Public Utilities Committee

AGENDA

We have received the set of documents included in the August 27, 2020 Final Plat Submittal for proposed new residential development slightly south of CTH MN, north of the railroad tracks and west of CTH AB for a project called Rosewood Fields. The plans and stormwater management report have been reviewed from a public works perspective. Our comments are shown below, organized by the appropriate document and/or drawing sheet number.

OVERALL GRADING PLAN
ROSEWOOD FIELDS
 VILLAGE OF MC FARLAND, DANE COUNTY, WISCONSIN

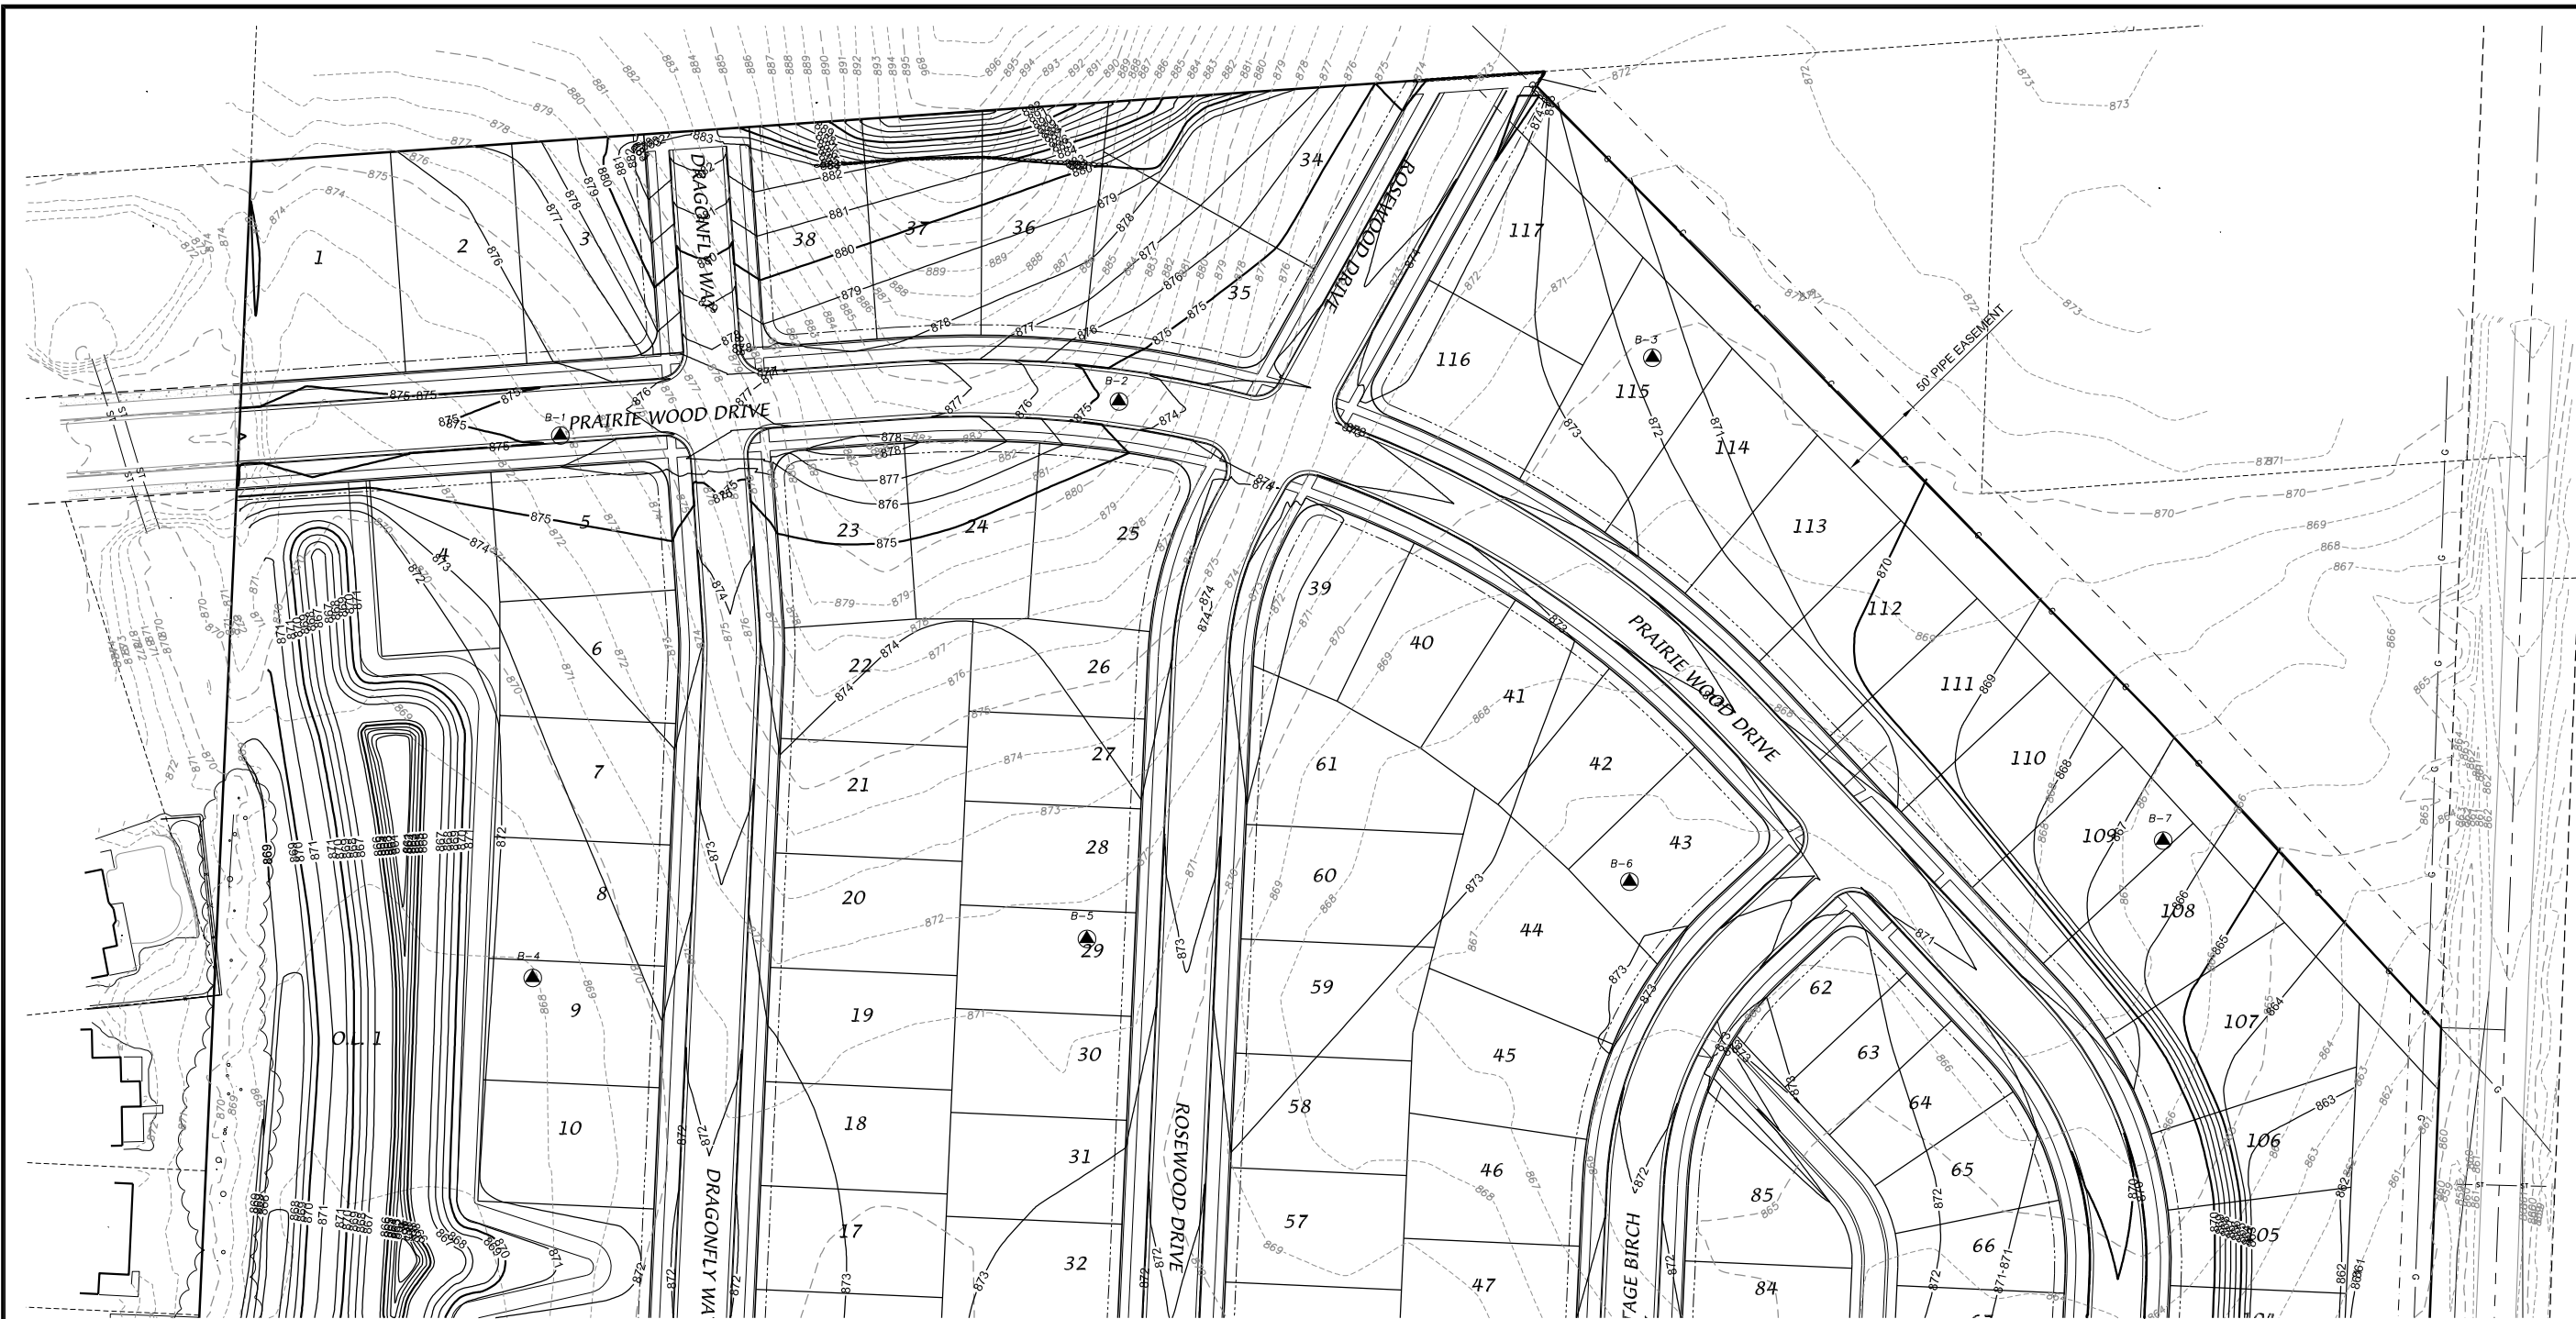
On Sheet 2 Prairie Wood Drive is mislabeled as Vintage Birch Way.

SITE GRADING PLAN
ROSEWOOD FIELDS
 VILLAGE OF MCFARLAND, DANE COUNTY, WISCONSIN

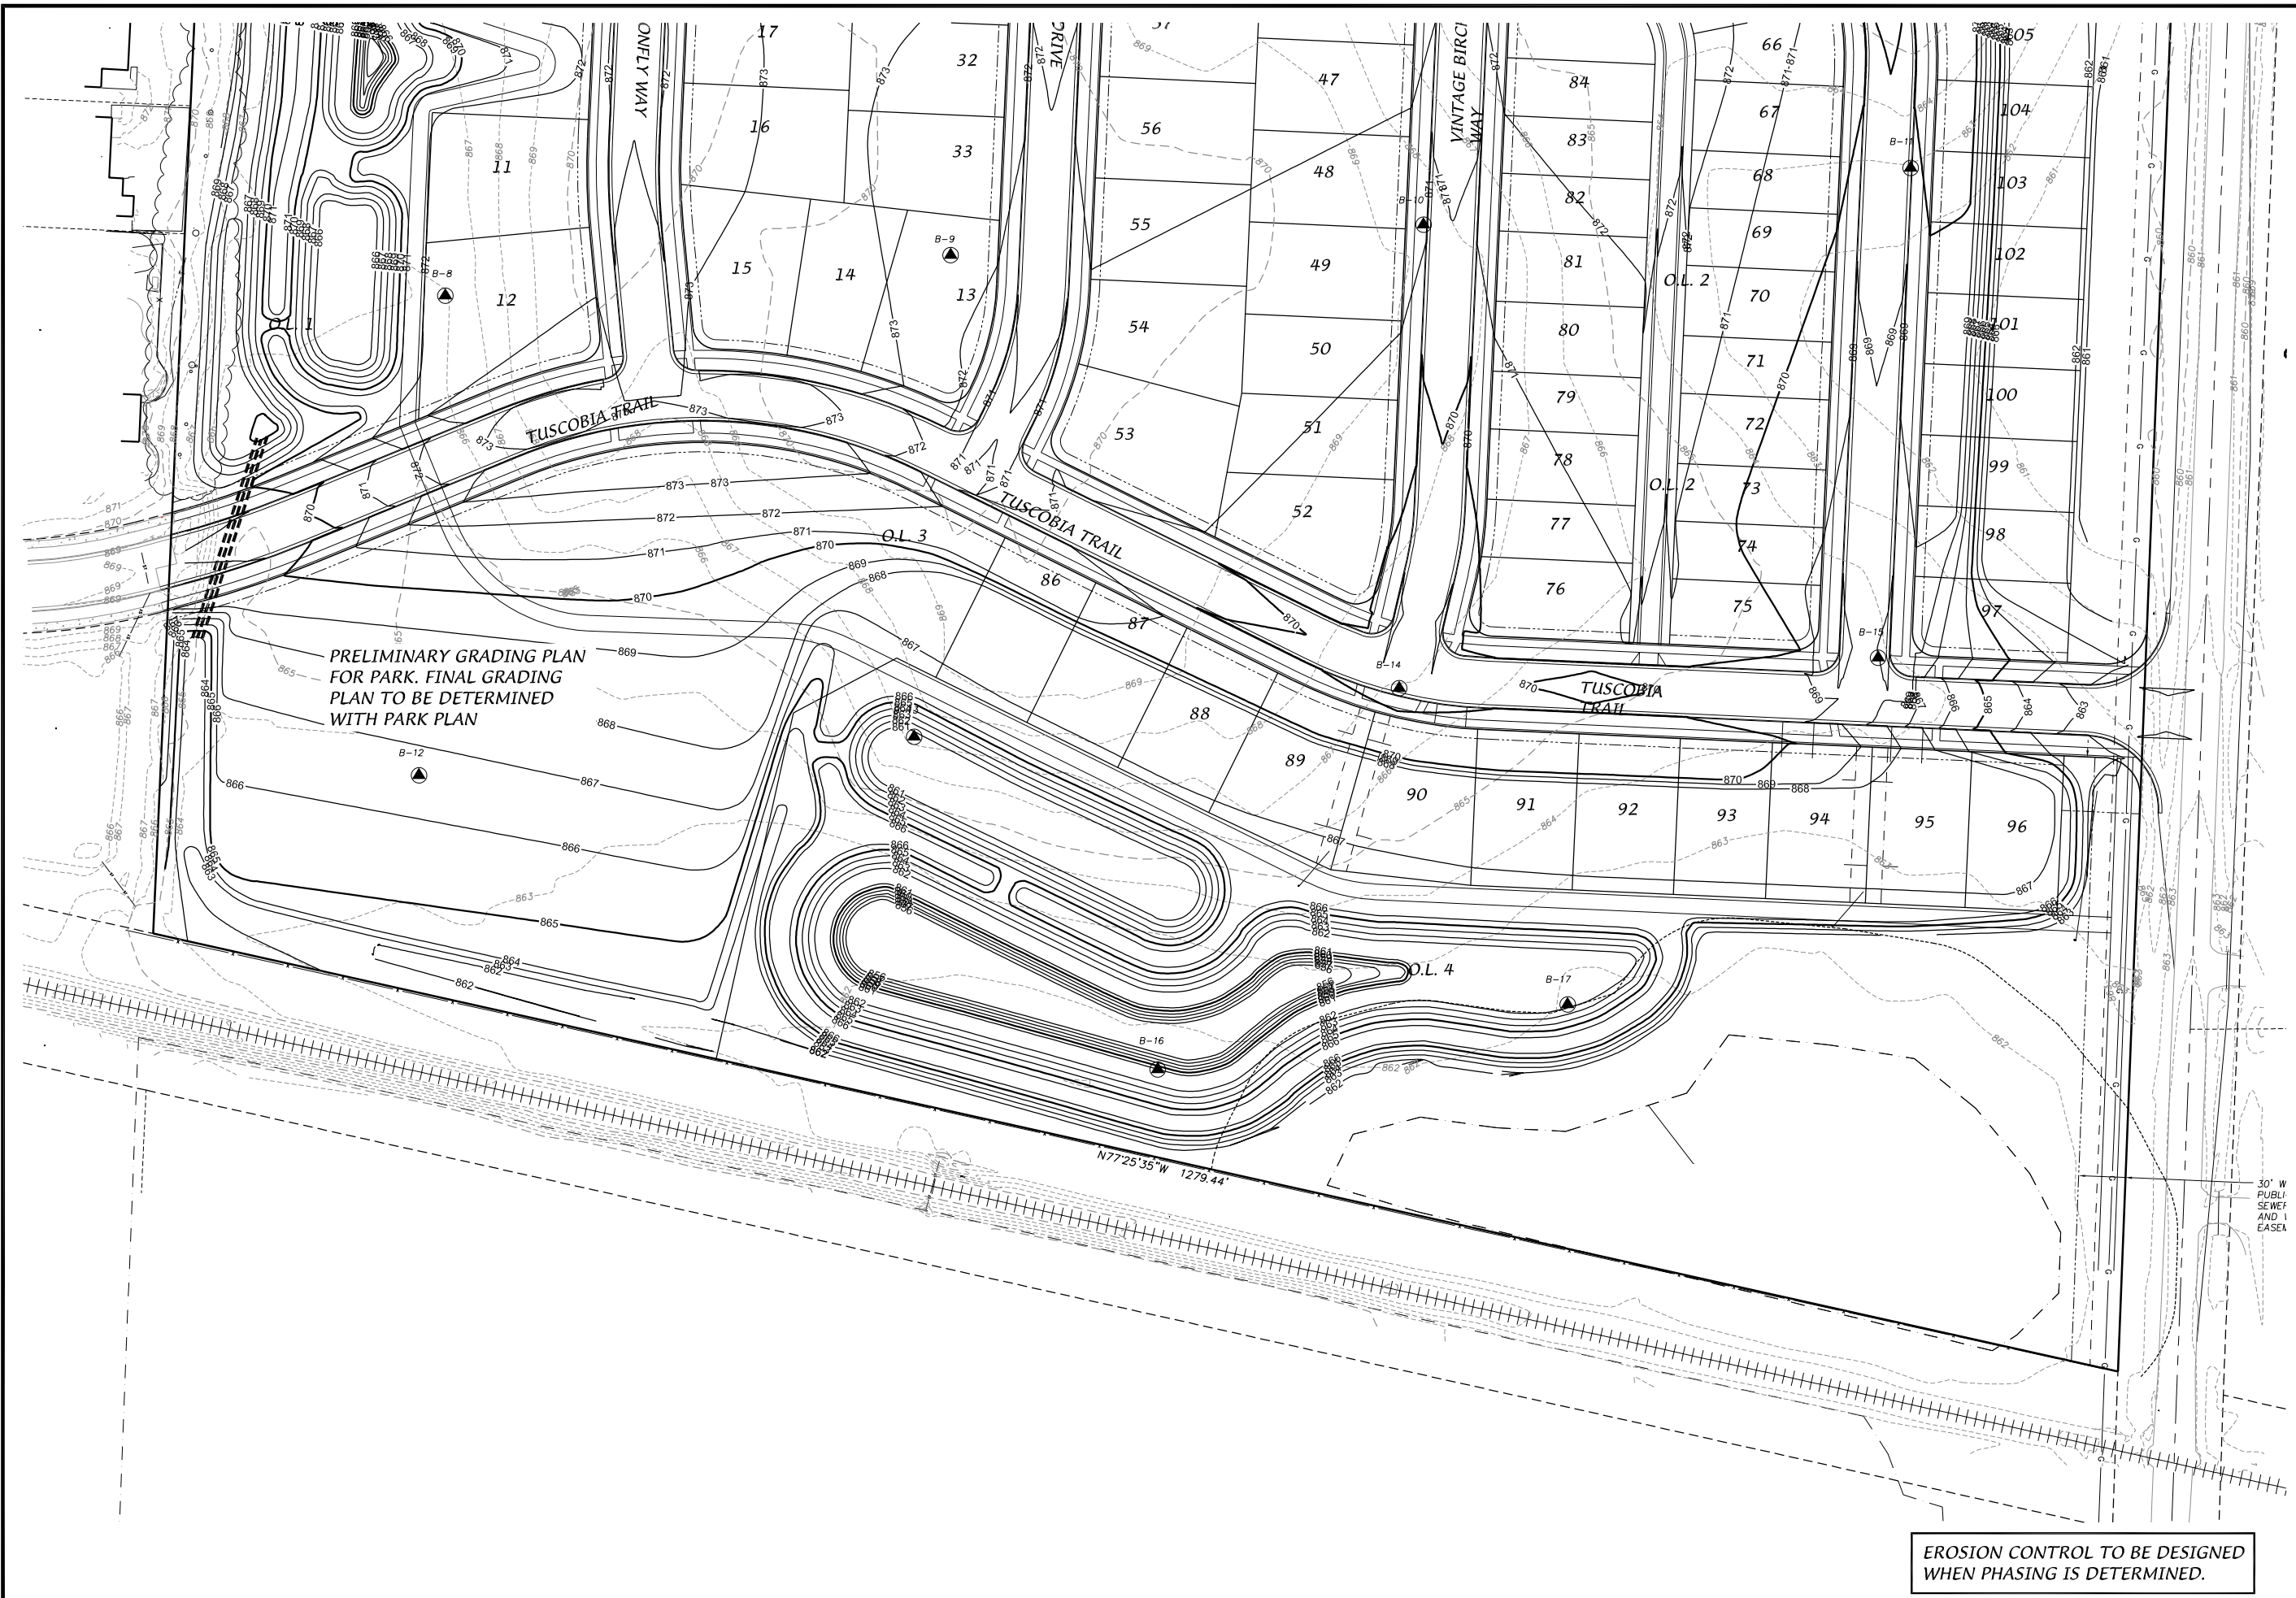
- The proposed right-of-way width is 60 feet, consistent with Village minimum standards and also recent residential streets. This will allow for on-street parking on both sides of the street and ample (7.5 foot) terrace space for tree plantings, if desired.
